Linac to BLIP Caps

RSC Meeting August 13, 2015

Goal

- Review Caps with Raster upgrade
- Plan for future upgrades
- NEPA commitment to extend BLIP-Y cap to 10 feet past the tunnel wall

Operating History

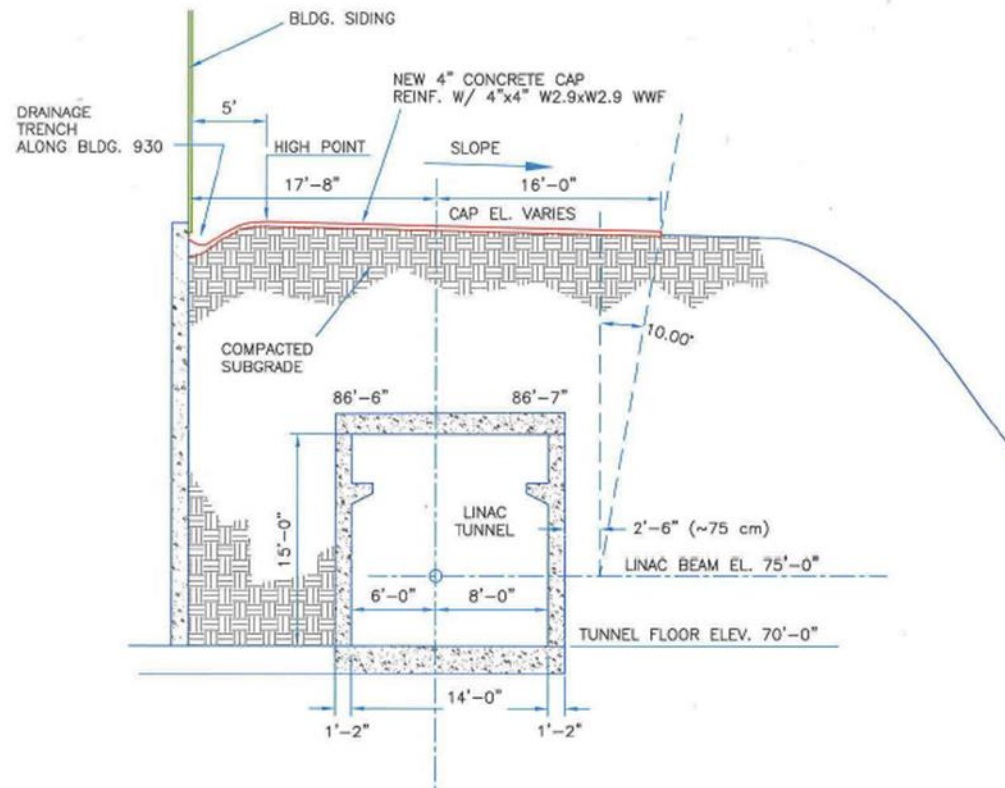
During 2003 review—not expected to have increases in operating beam power
See we are a factor of six higher at present

BLIP-Y Cap

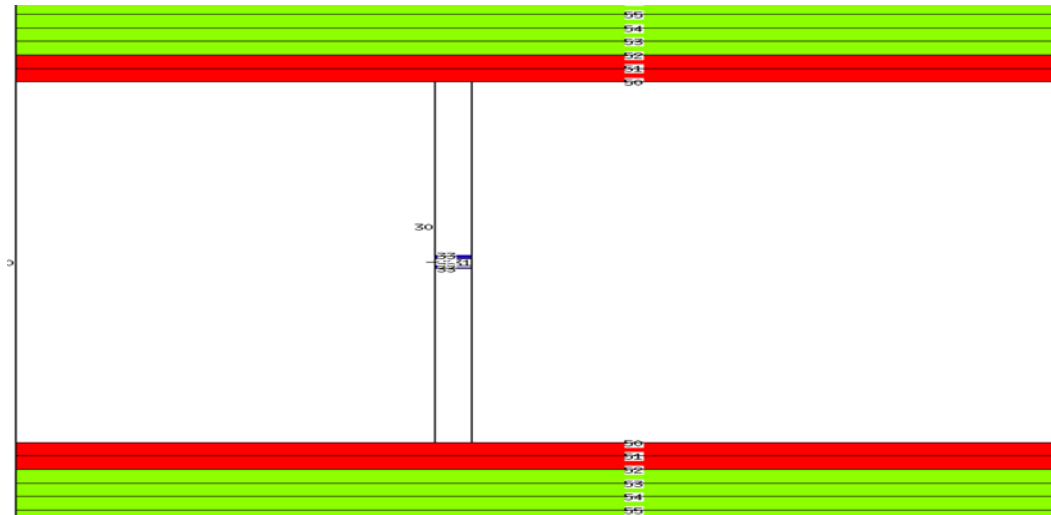
Tunnel slope shown wrong—slopes to outside. Same is true for the HEBT tunnel roof.

Blip Target

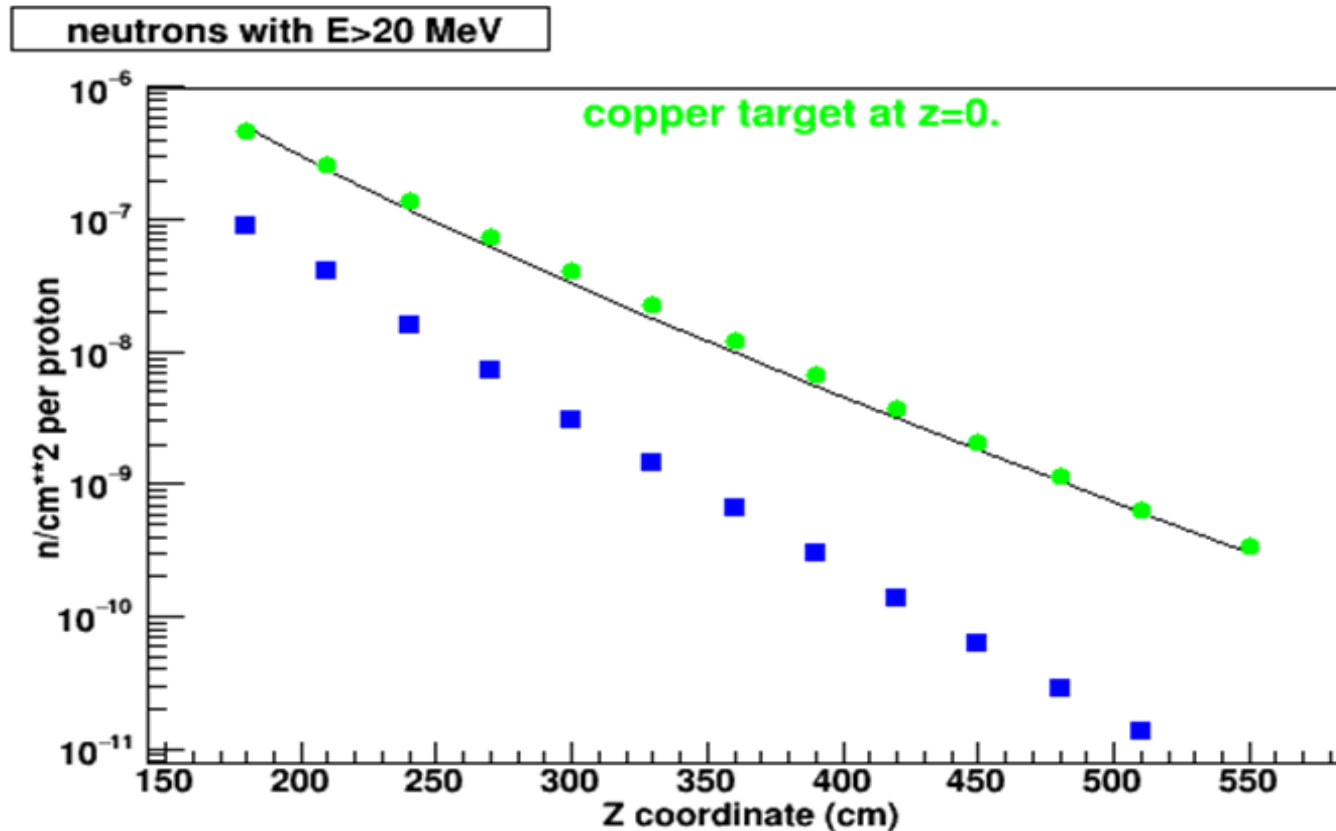
Forward radiation– Attenuation length 71 cm
Cap must extend to 1140 cm d/s of target (37 ft)

BLIP Rastering
Magnet
Neutron Flux
($n \cdot \text{cm}^{-2}$ per incident proton)

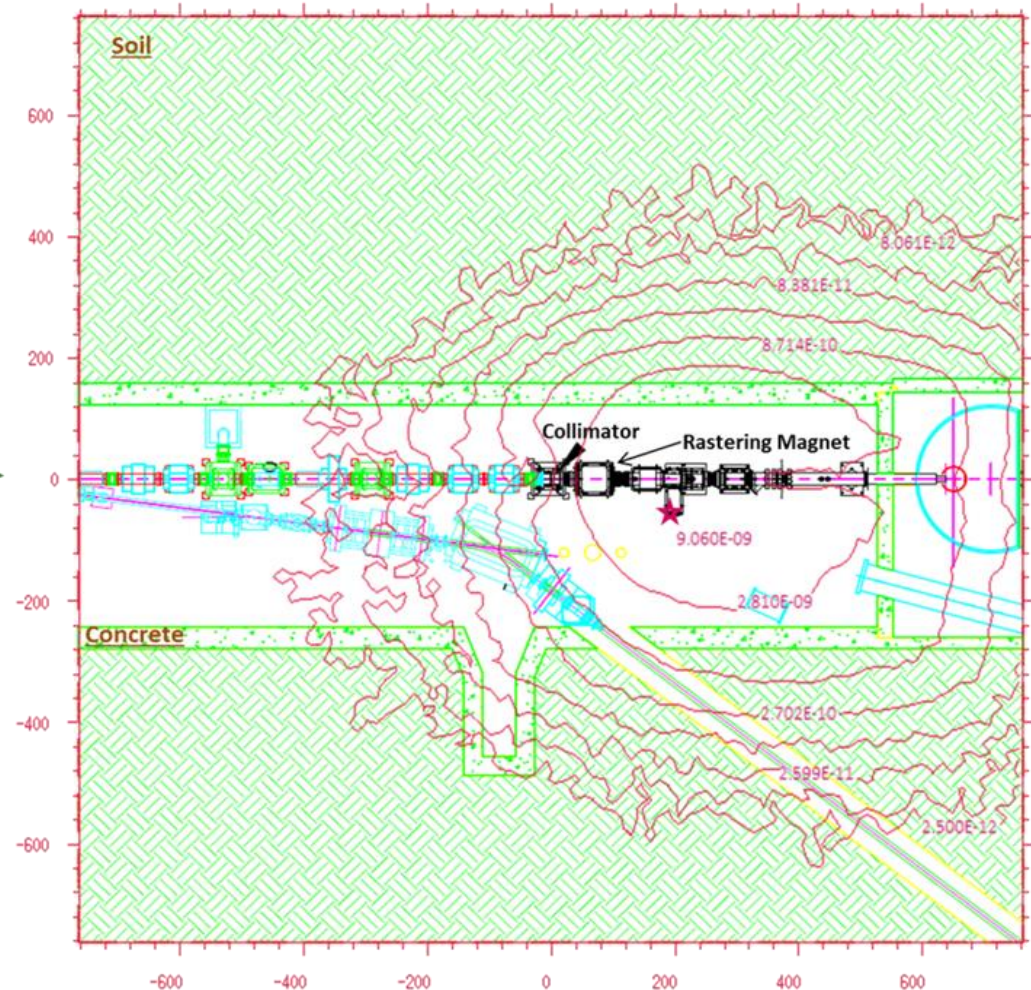
HEBT side 340 cm
REF side 280 cm
Mine 310 cm
Then add 130 cm for 10
degrees

Groundwater elevation

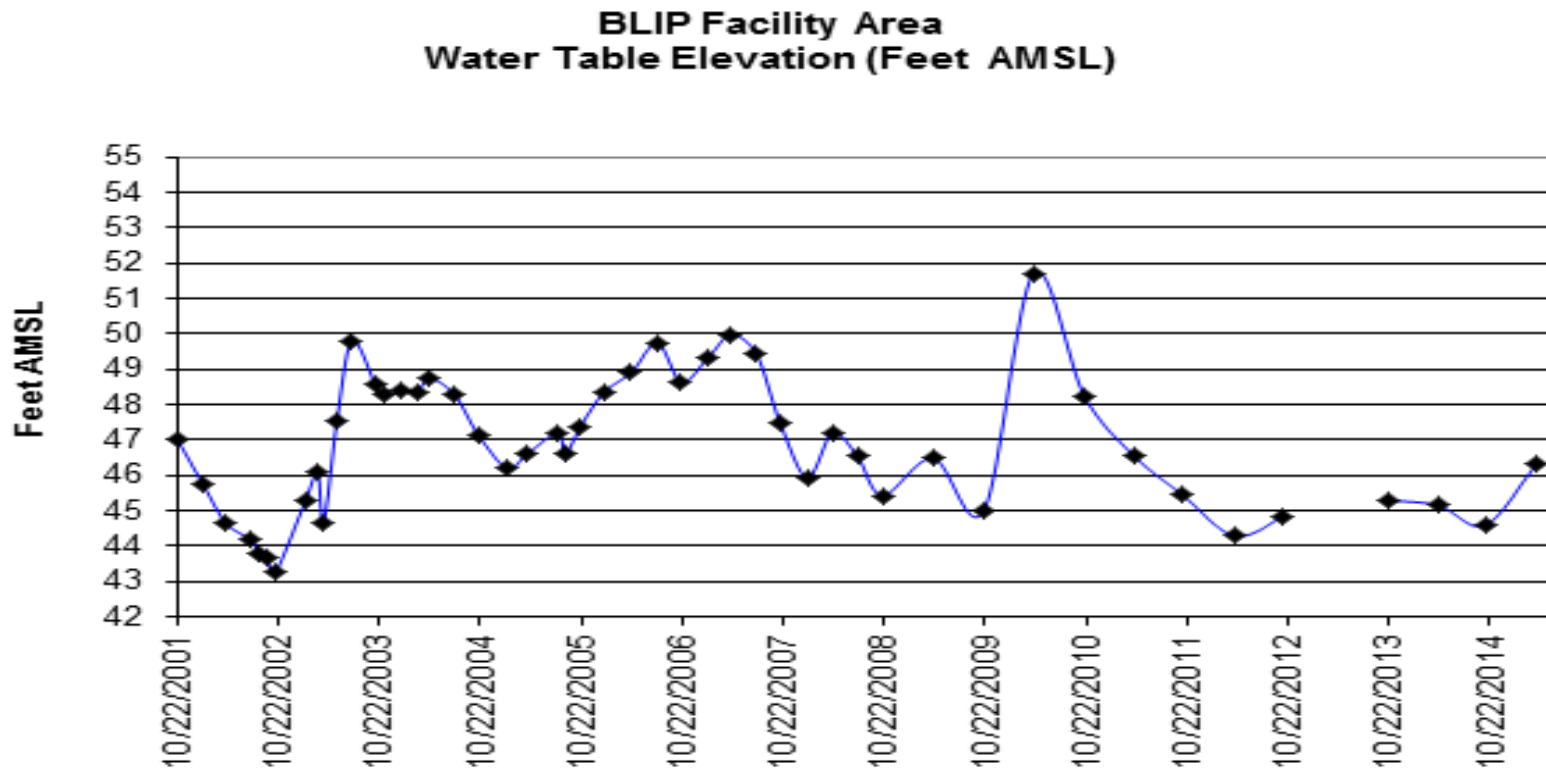
The well in 4/15 was 2690 pCi/l rather than less than 1000
Large losses occurred in FY14 due to vacuum leak
